# Product Change Notification - SYST-15GZZV803

**Date:** 24 Aug 2017  
**Product Category:** Ethernet Switches  
**Affected CPNs:**    
**Notification subject:** ERRATA - KSZ9896C Silicon Errata & Data Sheet Clarification Errata Document Revision  
**Notification text:** SYST-15GZZV803

## KSZ9896C Silicon Errata and Data Sheet Clarification

**FIGURE 1: IEEE DOCUMENT PAGE 6**

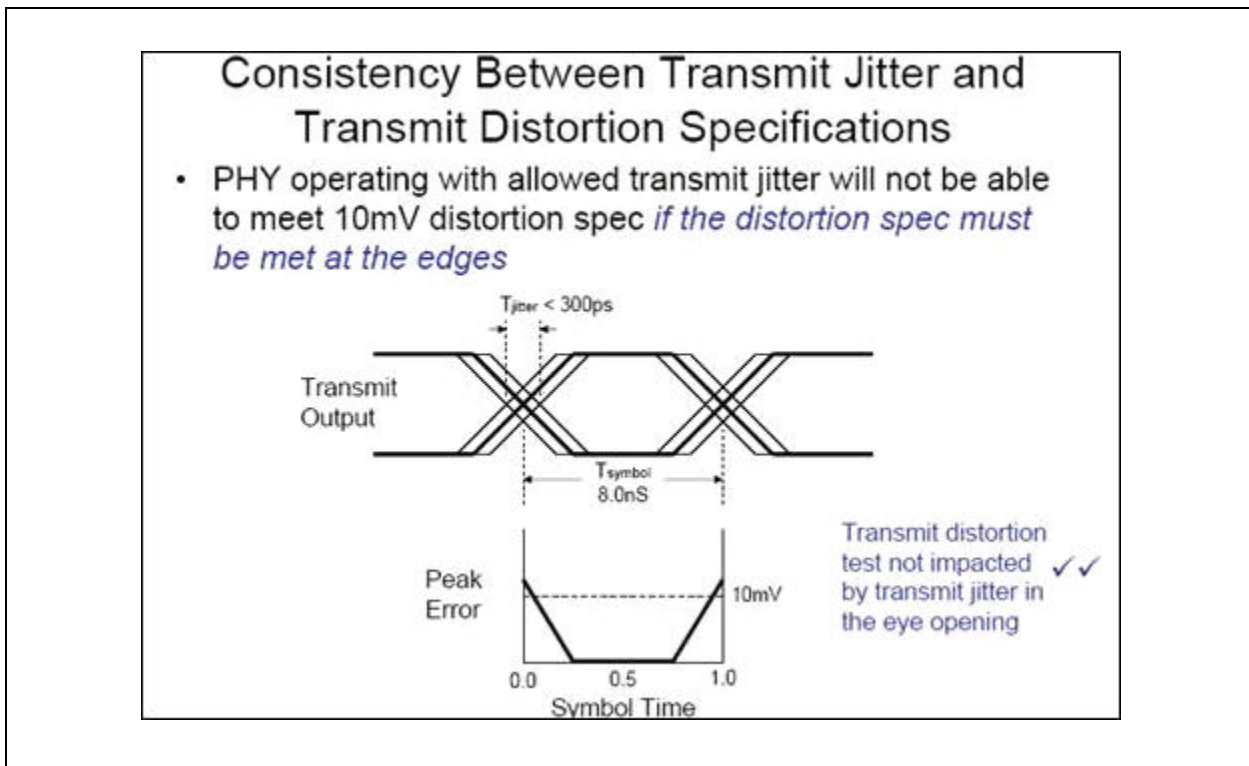
IEEE testing calls for <10mV peak transmitter distortion for at least 60% of the UI within the eye opening. However, this measurement might not be valid, as the transmit distortion test is sensitive to transmit jitter. Refer to the explanation below, taken from the aforementioned IEEE document.

The Gigabit Transmit Distortion Testing document indicates:

- On page 6, a contradiction between Transmit Jitter and Transmit Distortion requirements:

**FIGURE 2: IEEE DOCUMENT PAGE 7**

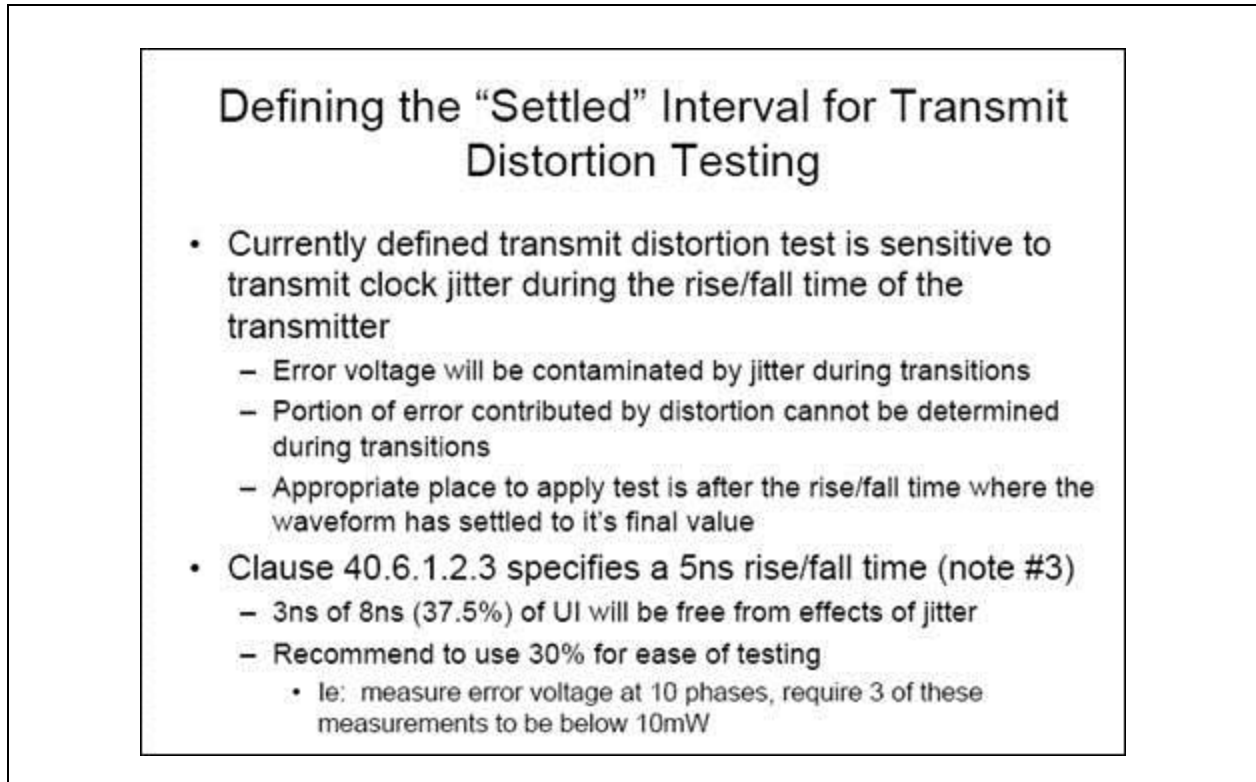
- On page 7:
  - The transmit distortion test is sensitive to transmit clock jitter during the rise/fall time.
  - It is recommended to change the requirement to use at least 30%, instead of at least 60%, of the UI within the eye opening for the <10mV peak transmitter distortion.
